## AGENDA

## **Plan Commission Minutes September 16, 2025, at 7:00 P.M.**

**AGENDA ITEM:** Discussion and recommendation to the Village Board to approve a Final Plat for Sperle Corners, including associated Street and Utility Plan, Stormwater Management Plan, and Development Agreement, submitted by Lakestone Properties for a 147-unit residential subdivision located at parcel 0610-024-9691-1.

**SPERLE CORNERS - VILLAGE OF MCFARLAND**  
**OVERALL GRADING & STORM WATER MANAGEMENT PLAN**  
 SHEET: C-3  
 DATED: SEPTEMBER 22, 2025

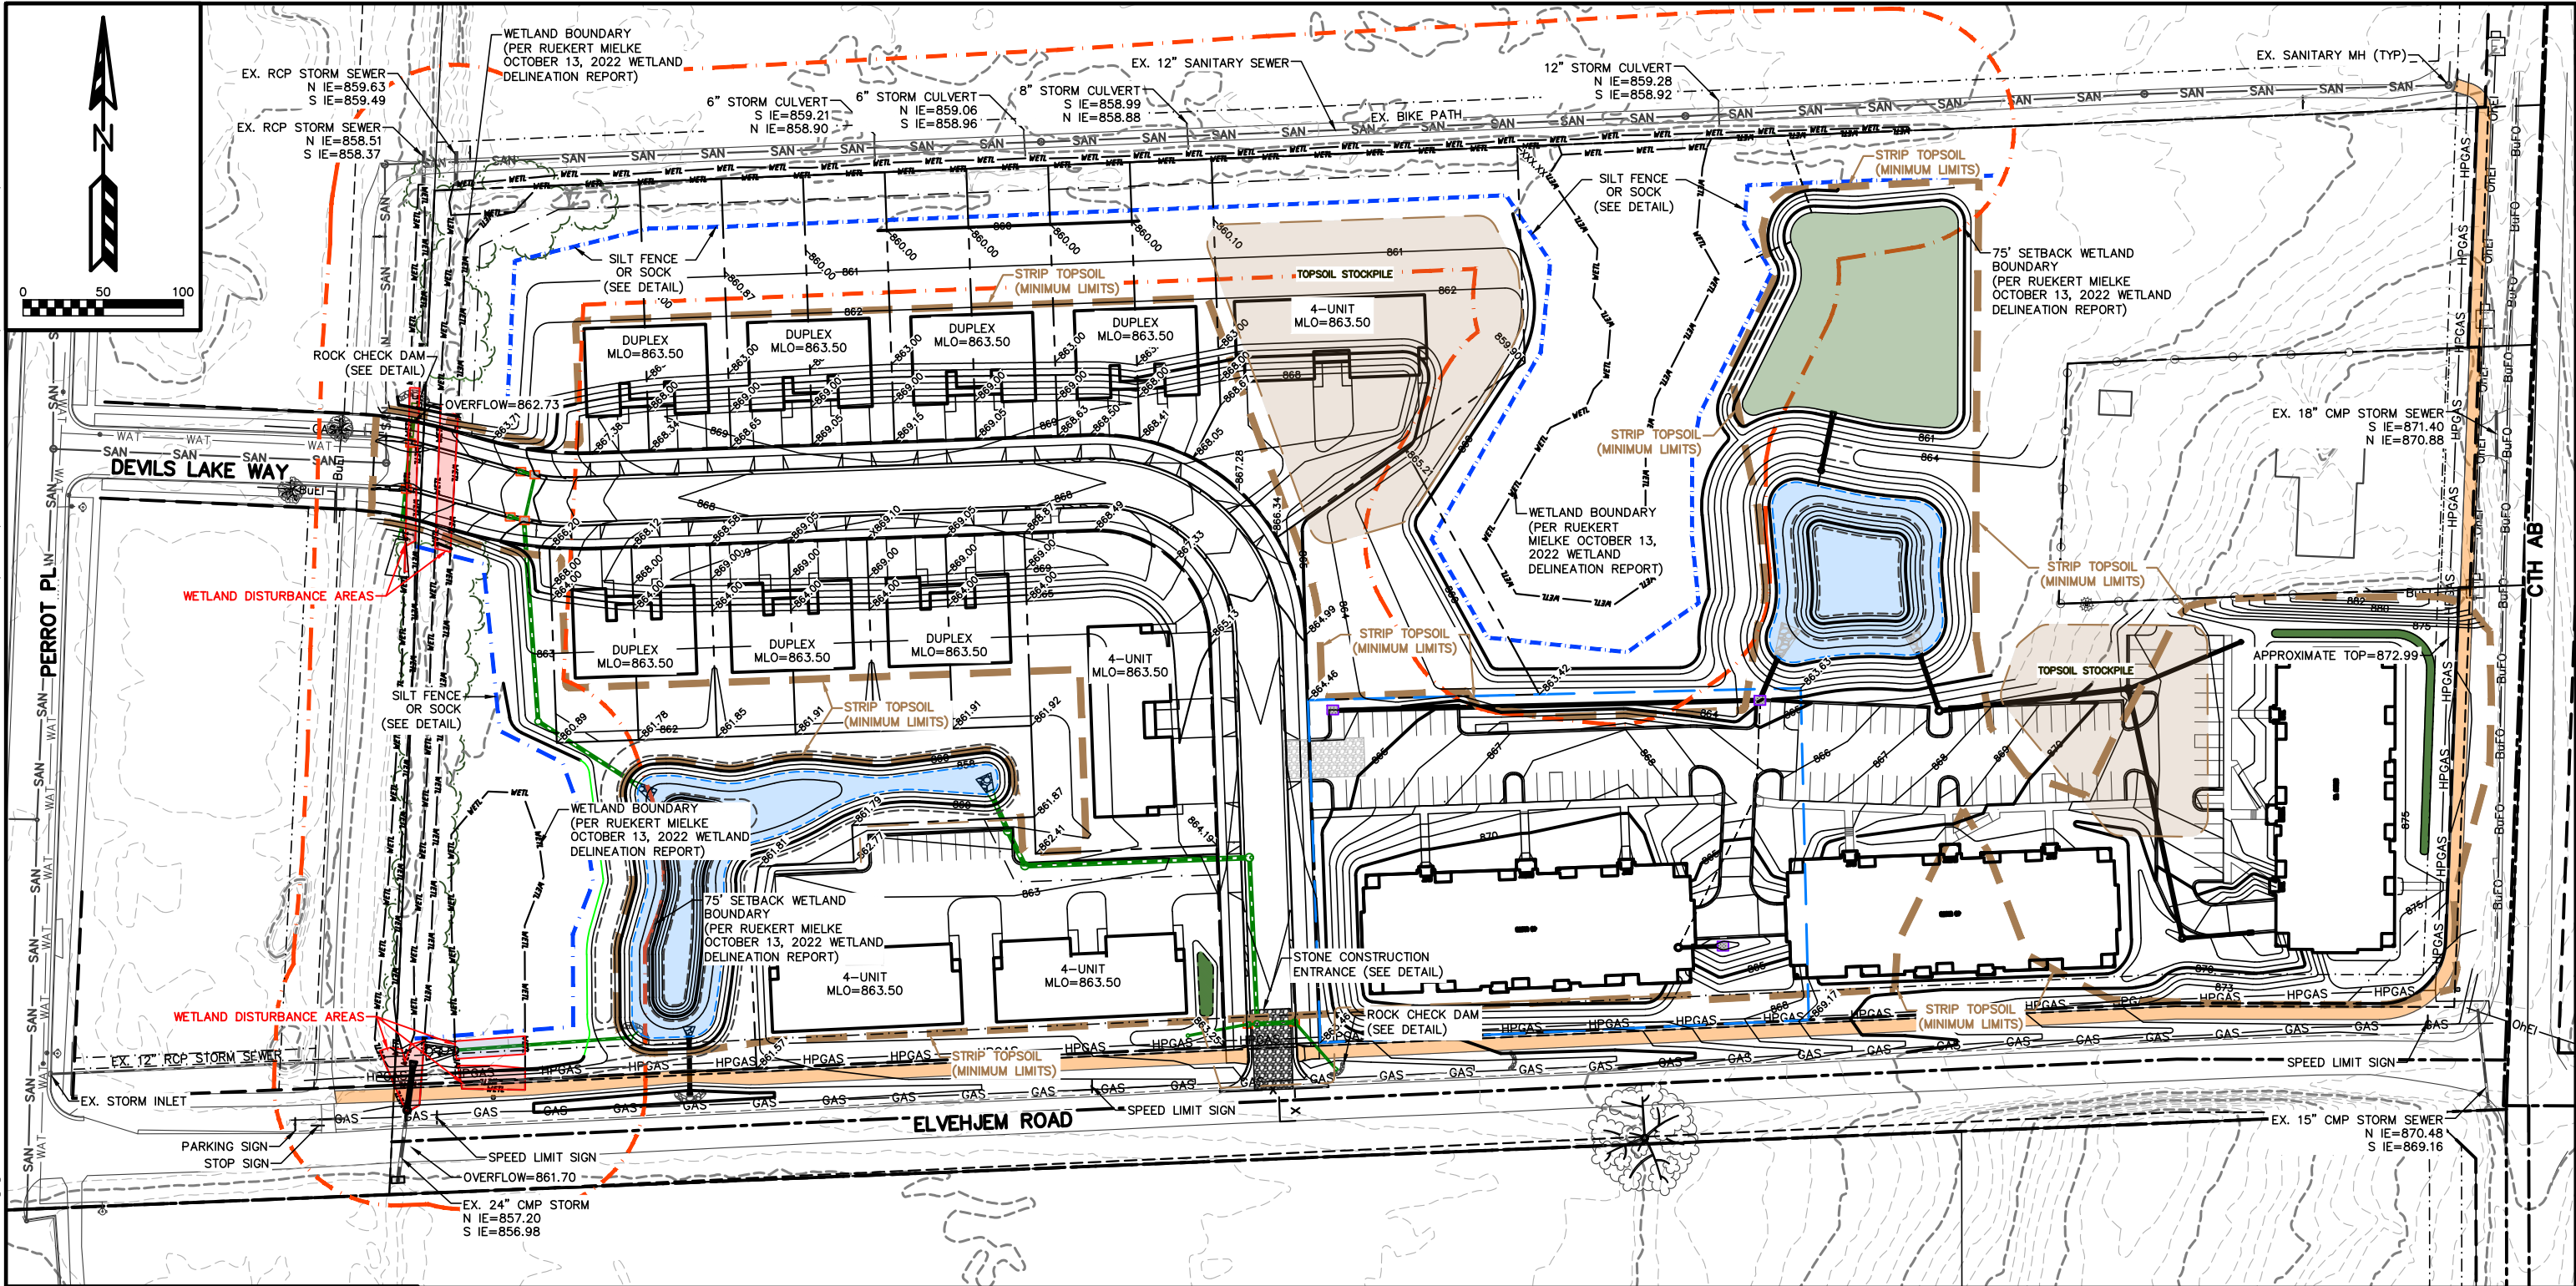
#### Sheet C-3

#### Sheet C-3

**SPERLE CORNERS - VILLAGE OF MCFARLAND**  
 FIRE LANE PLAN  
 SHEET: 1 OF 1  
 DATED: OCTOBER 3, 2025

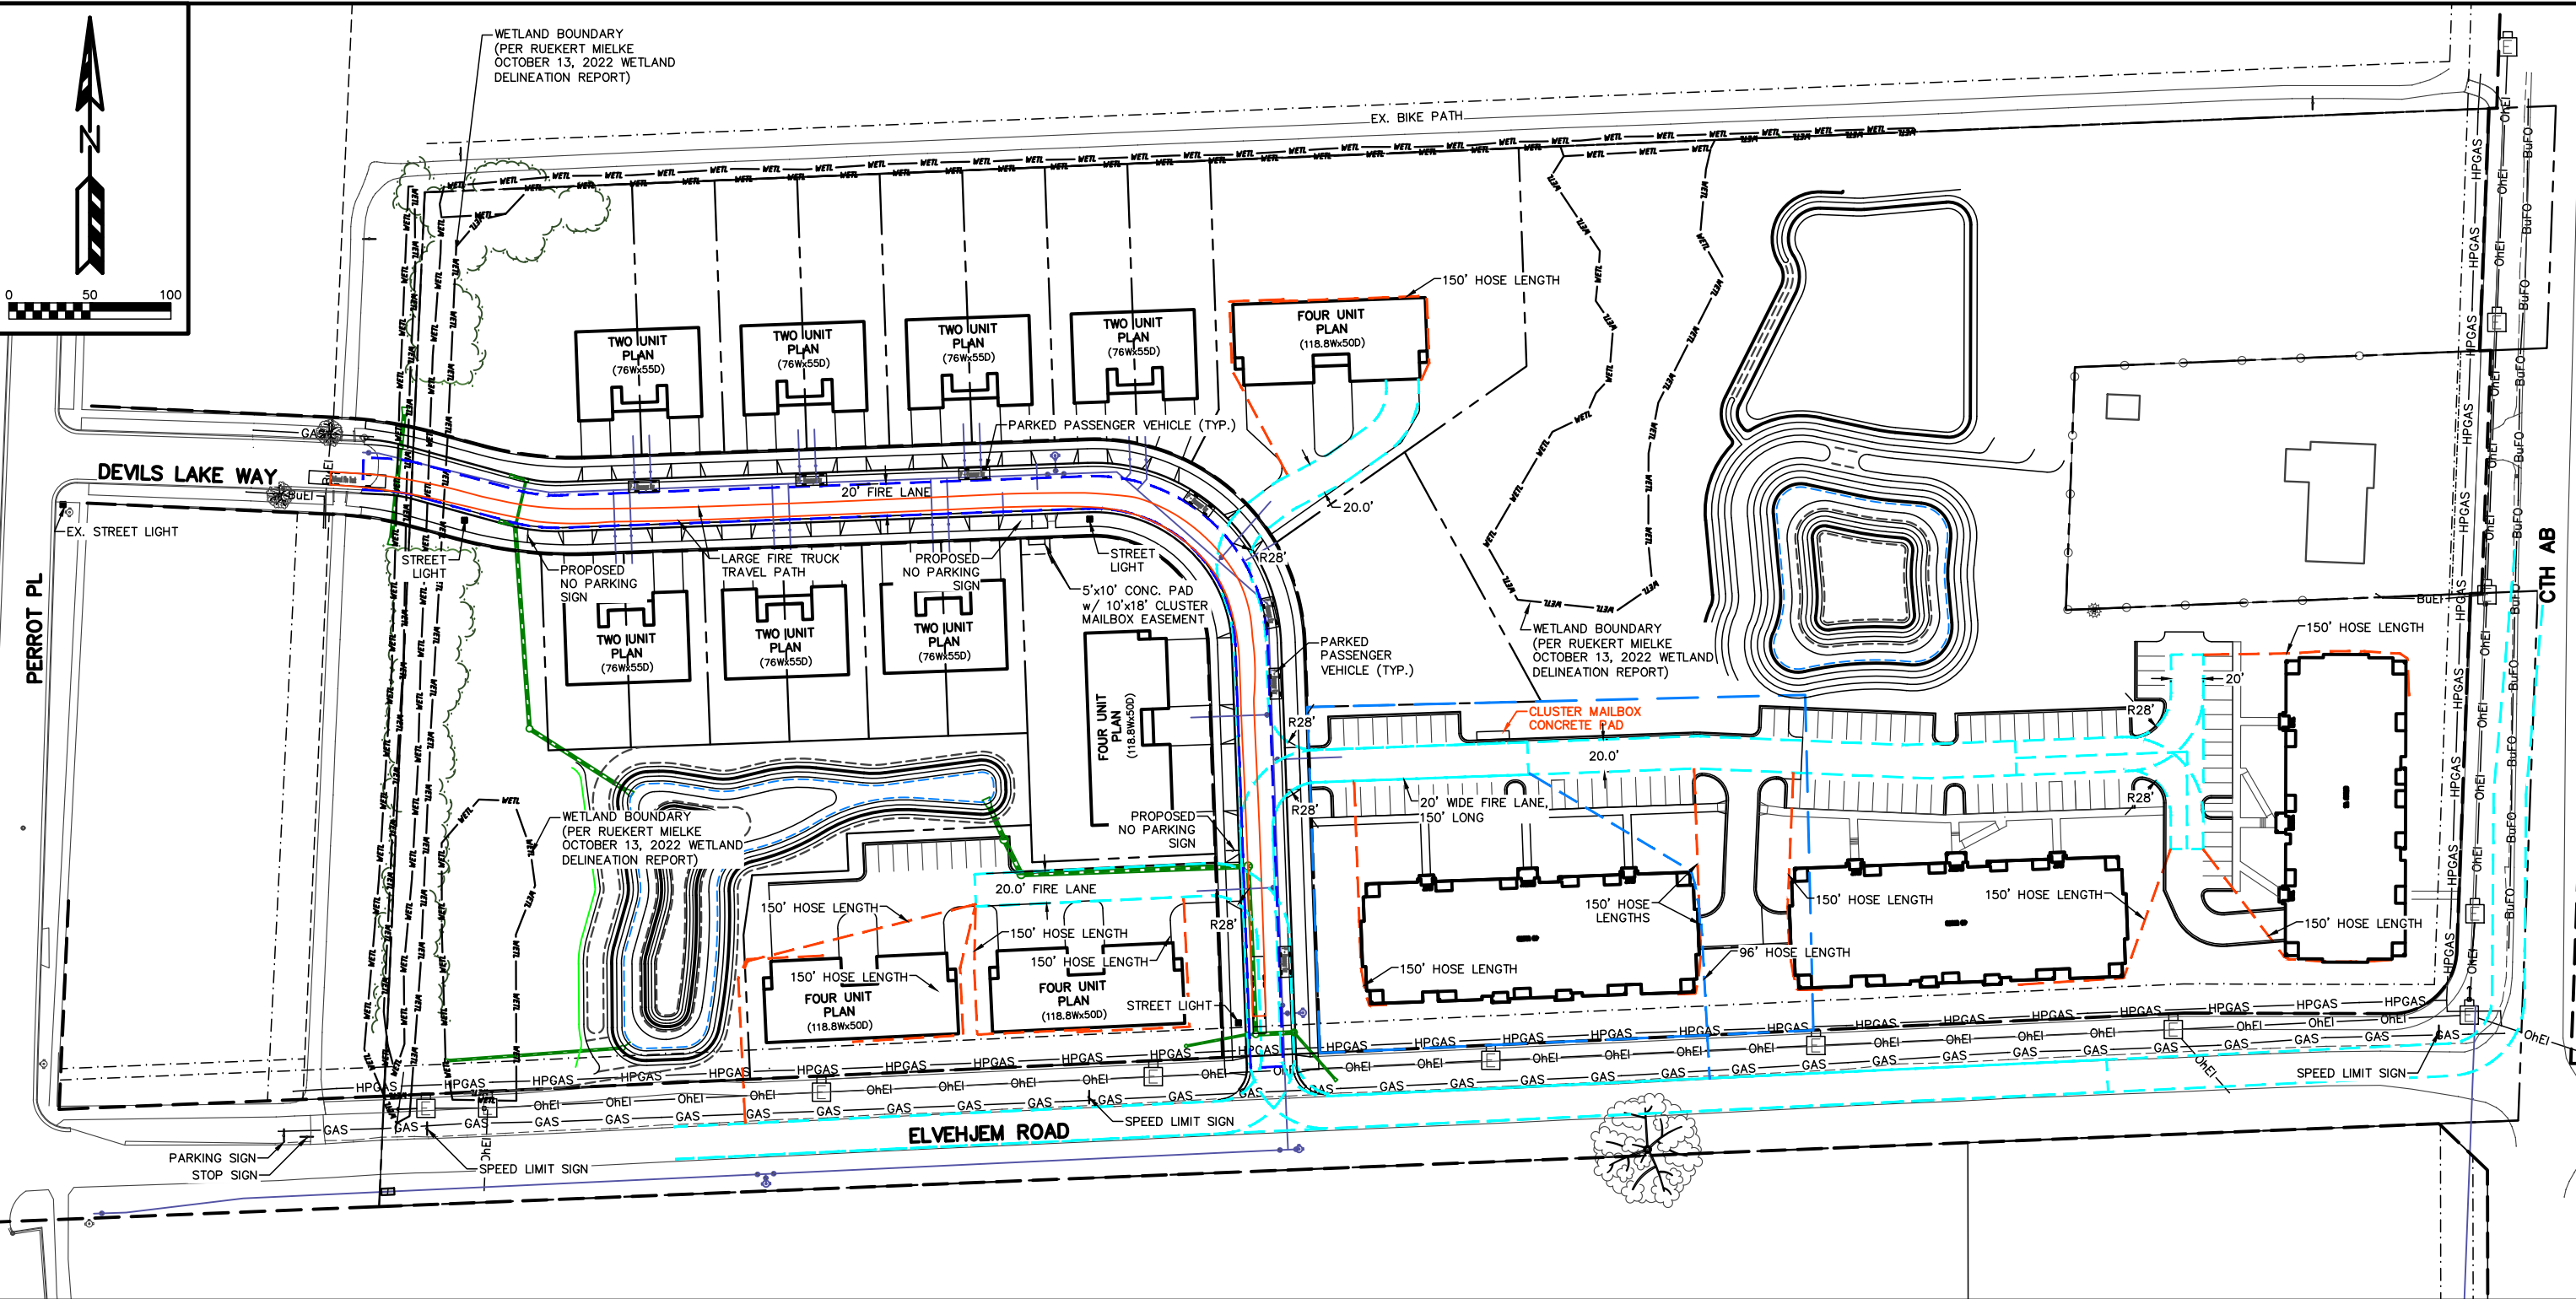
- Fire Lane Plan. The packet includes a Fire Lane Plan (dated October 3, 2025); however,

it does not address all of the concerns raised in the Fire Chief's September 5 review letter. Amendments are needed to account for turning from north/west for lots 1 and 17, a 26' fire apparatus access road width within 20 feet of a hydrant and a 26' wide aerial access road will be required on Lot 18 because of buildig's roof edge exceeds 30' from the ground plane.
